STAFF RECOMMENDATION

1401 Roberts Avenue

Application: New Construction—Outbuilding (Detached accessory dwelling unit)

District: Eastwood Neighborhood Conservation Zoning Overlay

Figure 2: The DADU as proposed is lower than the house due to the grade, but is not subordinate to the primary building as measured from finished floor height.

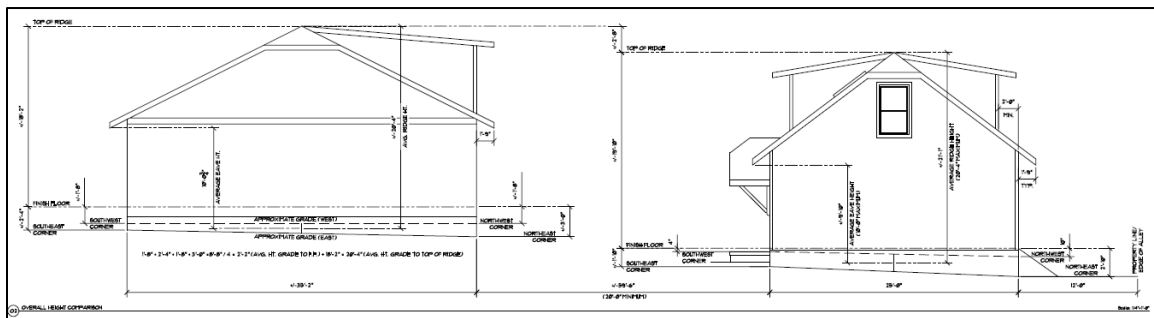
Because of variations in grade, the Commission has determined that the eave and ridge height measurements of the historic house should be taken from the top of the foundation and/or finished floor line. The ridge height of the primary building is eighteen feet, two inches (18' 2") from the finished floor. The proposed ridge height of a DADU is typically measured from grade because outbuildings are typically constructed on a slab. Because of varying grade, this DADU has a foundation, so the measurement was taken from the finished floor in order to ensure that the comparison to the historic building was proportional. The proposed DADU is nineteen feet, ten inches (19' 10") from the finished floor height.

In this case, as the outbuilding exceeds the height of the primary building, staff recommends that the overall height be reduced to eighteen feet, two inches (18' 2"), so as not to exceed the height of the house.

1. That the ridge height is reduced to be no taller than eighteen feet, two inches (18' 2");
2. Staff approve the windows, doors and garage doors and color of roofing prior to purchase and installation.
